# Access Compliance Report

## Public Rights-of-Way

### (Curb Ramps)

Intersection ID: 15470	Main Street: AMITY_SPRINGS_DR	Cross Street: THORN_GROVE_LN	Location:	N
ADA ID: 4A90FE77307E	Ramp Type: Perp	Initial Pass/Fail: Fail	Overall Compliance: No	Severity Score: 23.75
Codes/Mitigation Info/Possible Solution		Field Measurements/Component Compliance

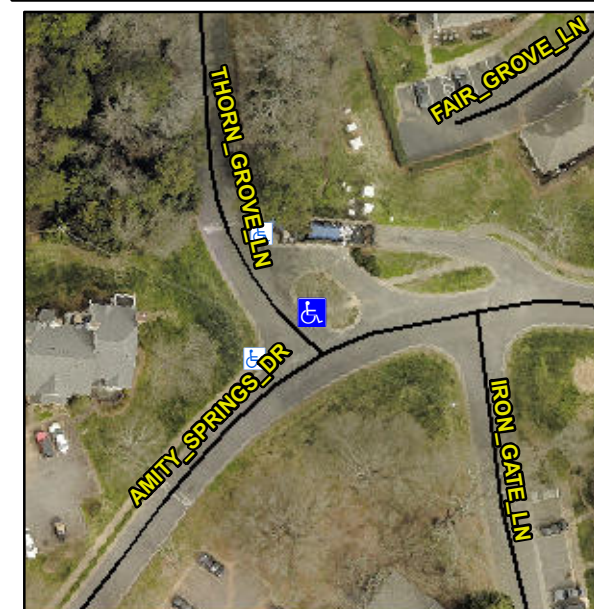
**Not Found, R304.5.1, R302.7**

Compliance	Description	Data	Compliance	Description	Data
N/A	Ramp Length (in)	44.0	Yes	Ramp Slope (%)	7.4
No	Ramp Width (in)	46.5	Yes	Ramp XSlope (%)	1.5
N/A	Flare Type LT	N/A	N/A	Flare Type RT	N/A
N/A	Flare Slope LT (%)	N/A	N/A	Flare Slope RT (%)	N/A
N/A	Flare Traversable LT?	N/A	N/A	Flare Traversable RT?	N/A
N/A	Landing Length (in)	N/A	N/A	DWS Provided?	N/A
N/A	Landing Width (in)	N/A	N/A	DWS Contrast?	N/A
N/A	Landing Slope (%)	N/A	N/A	DWS Length (in)	N/A
N/A	Landing X Slope (%)	N/A	N/A	DWS Full Width?	N/A
N/A	Landing Curb? (Y/N)	N/A	N/A	DWS Offset (in)	N/A
N/A	Shared Landing?	N/A			
N/A	Gutter Ponding?	N/A	N/A	Gutter Slope (%)	N/A
N/A	Gutter Lip Ht (in)	N/A	N/A	Gutter X Slope (%)	N/A
N/A	Painted X Walk1?	No	N/A	Painted X Walk2?	N/A
	X Walk 1 Direction	To SW		X Walk 2 Direction	N/A
N/A	X Walk 1 Width (in)	N/A	N/A	X Walk 2 Width (in)	N/A
	X Walk 1 Slope (%)	0.8		X Walk 2 Slope (%)	N/A
	X Walk 1 X Slope (%)	0.9		X Walk 2 X Slope (%)	N/A

N/A	Ramp inside XWalk1?	N/A	N/A	Ramp inside XWalk2?	N/A
	Road Slope (%)	N/A	N/A	Clear Space?	N/A
	Road X Slope (%)	N/A	N/A	Clear Space to XWalk (in)	N/A
N/A	Any Obstructions?	N/A	N/A	Storm Grate/Utility Hazard?	N/A
	Obstruction Type			Storm Grate/Utility Type	
		N/A			N/A
		No		Surface Condition? (G/P)	Poor

**Remove & Replace Entire Ramp.**
